Concerning Comments

r03-21, -22, -36, -39, -42, -43 On TDECQ

P802.3cd Ad Hoc

In Support Of Comments r03-21, r03-43 Against 50GBASE-FR/LR In P802.3cd D3.3

(1) 50G-PAM4 DML Measurements

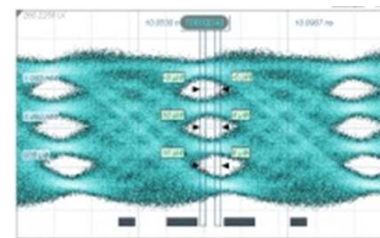
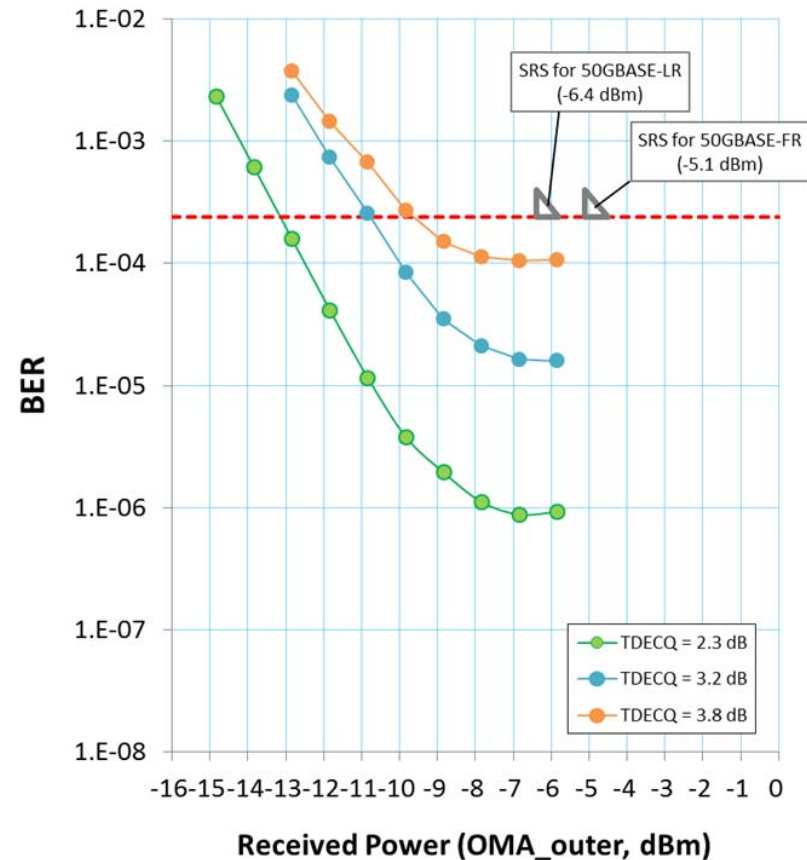
1. Rx Sensitivity << SRS even for SECQ (TDECQ) as high as 3.8 dB.
2. BER floor more than 1 decade below 2.4×10^{-4} for SECQ (TDECQ) as high as 3.2 dB.
3. TDECQ (max) of 3.2/3.4 dB for 50GBASE-FR/LR, respectively, are reasonable.

(2) 50G-PAM4 DML Measurements

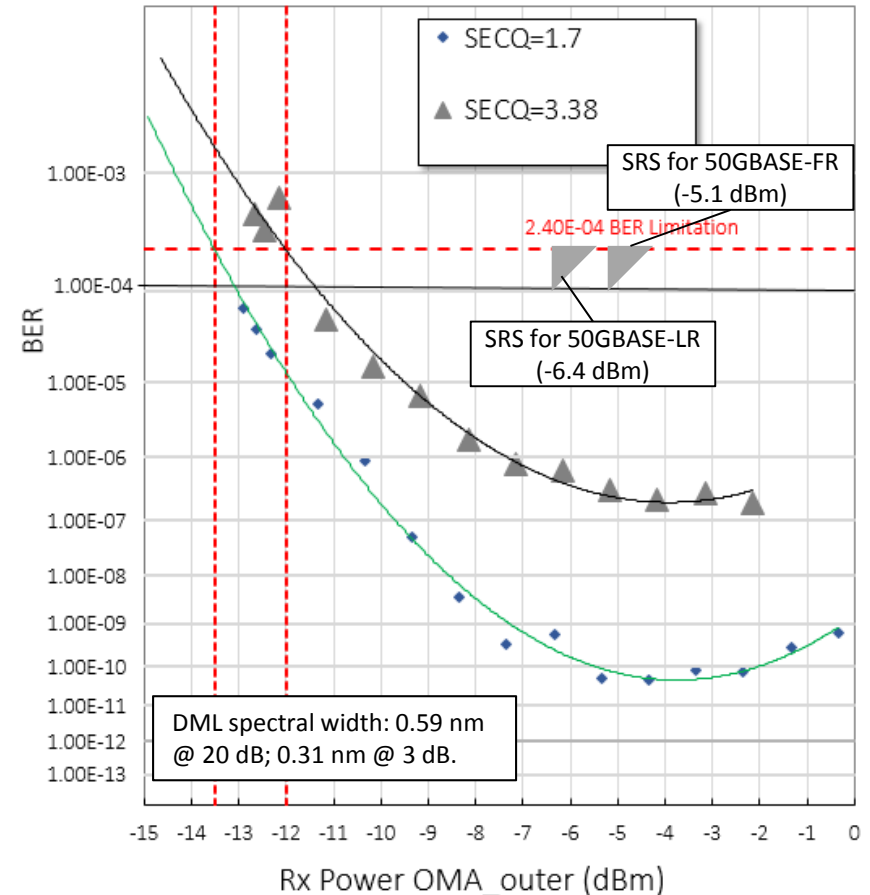
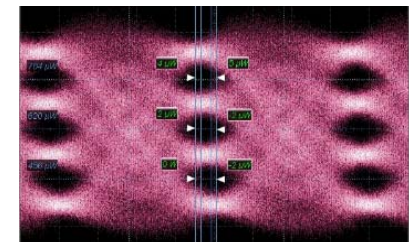
1. Rx Sensitivity << SRS requirement even for TDECQ > 3.4 dB.
2. BER floor << 2.4E-4 even for TDECQ > 3.4 dB.
3. In addition $TDECQ - 10 \log(C_{eq}) > 3.45 \text{ dB}$ ($C_{eq}=0.98$)
4. Skew-degraded TDECQ allows BER floor and Rx Sens to remain good.
5. TDECQ (max) of $\geq 3.2/3.4 \text{ dB}$ for 50GBASE-FR/LR needed for DML.

(1) 100G-PAM4 EML Measurements

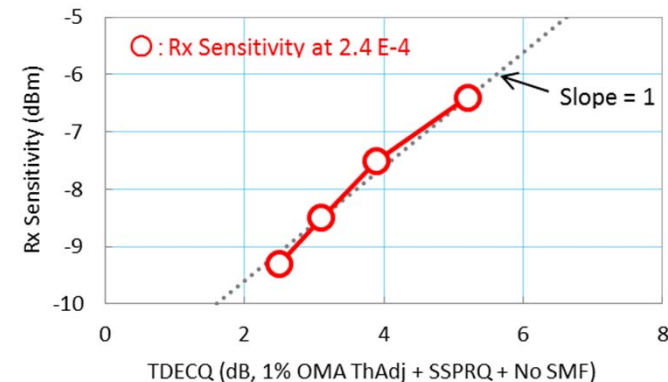
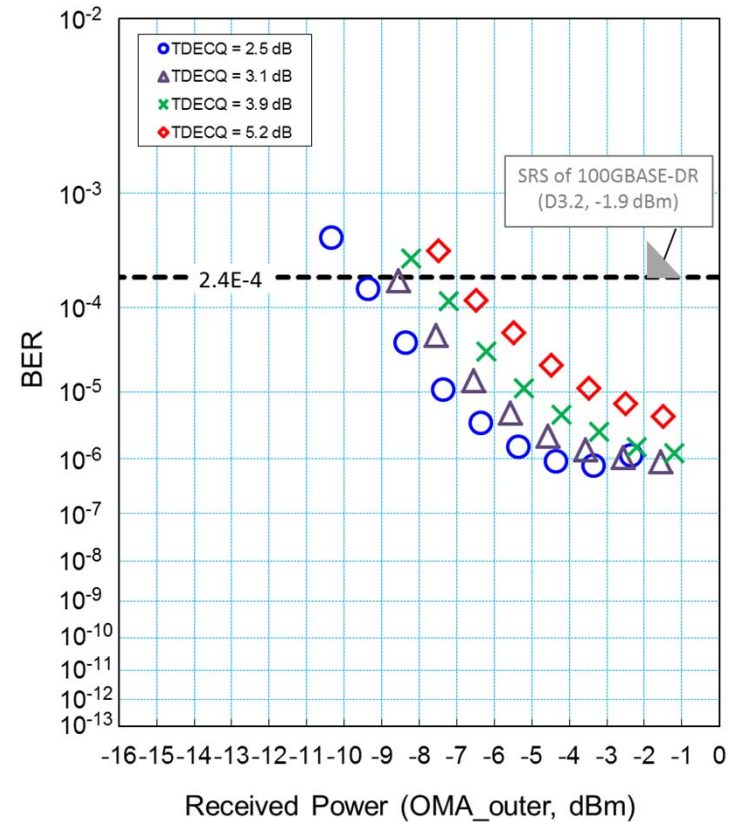
1. Rx Sensitivity \ll SRS and BER floor \ll $2.4E-4$ even for SECQ (TDECQ) as high as 5.2 dB.
2. Rx Sensitivity vs TDECQ has slope ~ 1 .
3. TDECQ (max) of 3.4 dB for 100GBASE-DR is reasonable.

(2) 100G-PAM4 EML Measurements

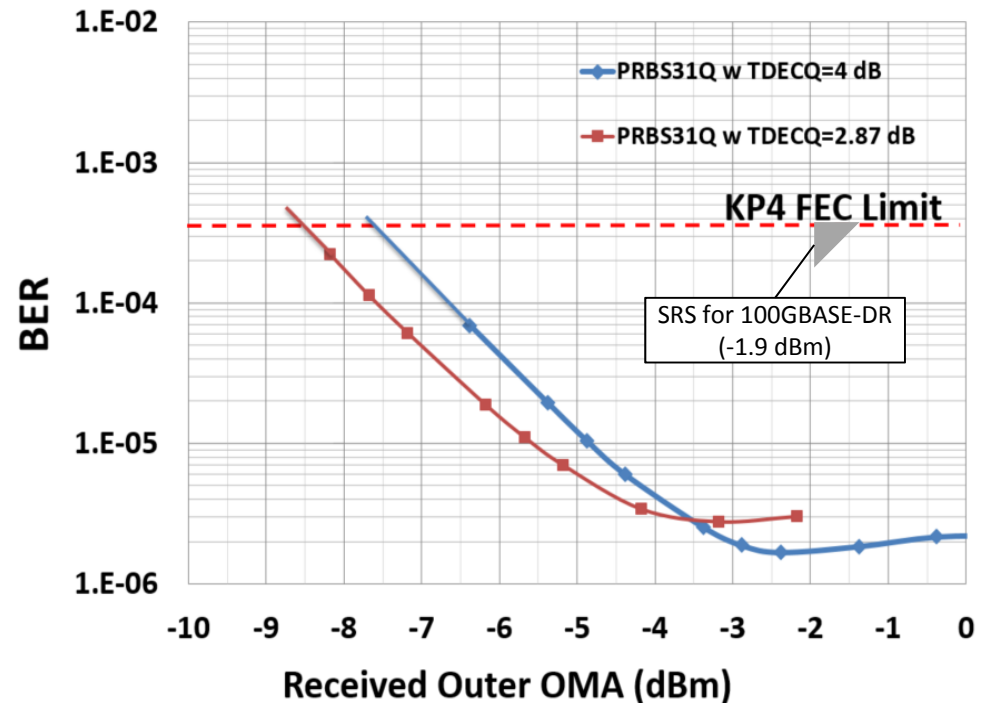
- Sensitivity correlates with TDECQ
- BER floor < 5E-6 didn't correlate well with TDECQ
- Rx Sensitivity OMA - TDECQ < -11 dBm stays good for TDECQ >3.4 dB.

(2) 100G-PAM4 EML Measurements (Cont.)

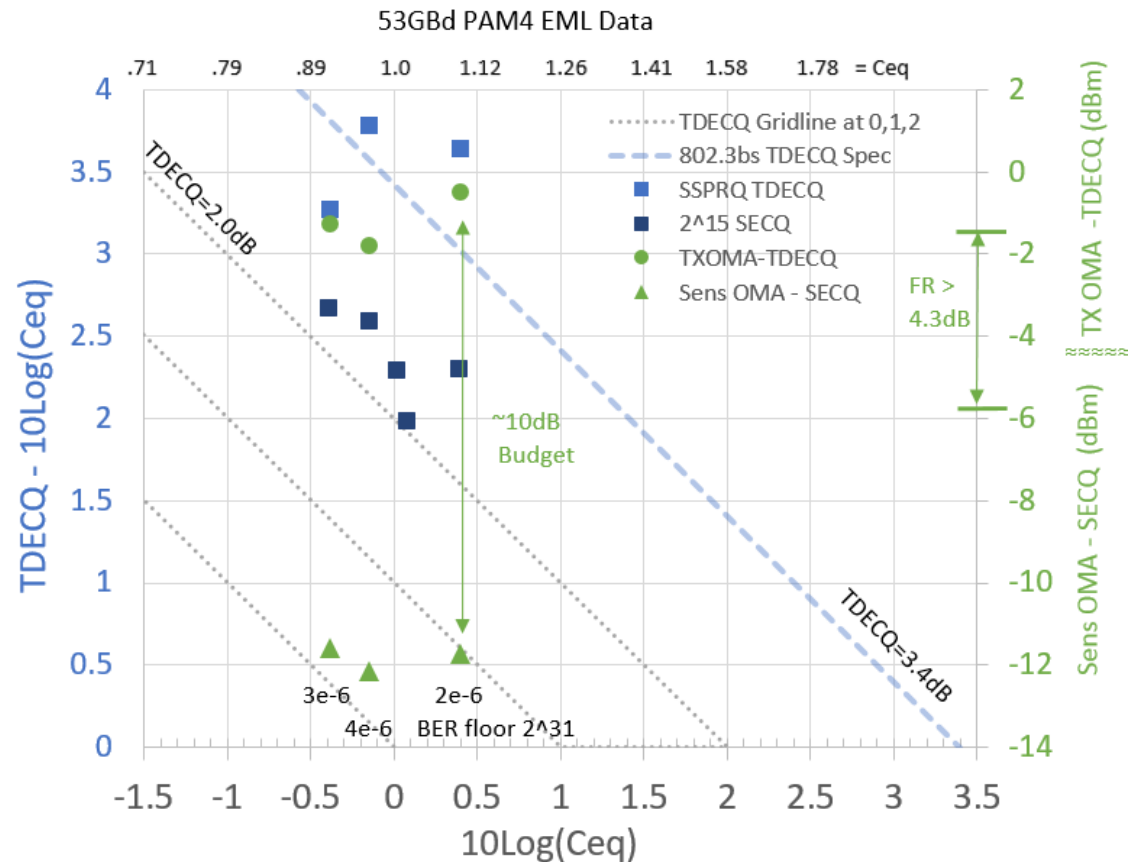
- ~10dB link budget is obtainable with TDECQ - 10Log(Ceq) > 3.5dB.
- As MPI is added beyond the spec, Rx Sensitivity degrades only < 1.4dB as TDECQ degrades >>4dB.
- High TDECQ does not demonstrate a “cliff” in Rx Sensitivity as long as the SNR maintains a BER floor < 1E-4
- Requiring distributions at +/-0.05 UI to support threshold offset inaccuracies is similar to creating a square, instead of a diamond, mask margin.
- Conclusion: TDECQ - 10Log(Ceq) should not be used to limit higher noise transmitters.
